HAZOP Template

Zoraya Chemical Mixing Plant / Serrah Engel / 26 Apr 2023

Hazard & Operability Analysis (HAZOP)

Photo 1

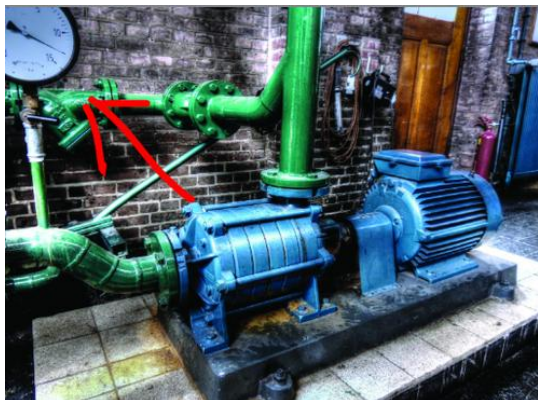
No RO water flow

Centrifugal pump loses priming or valve closed totally

Resulting in highly concentrated solution

Hydraulic pressure gauge should be reviewed and maintained on a regular basis.
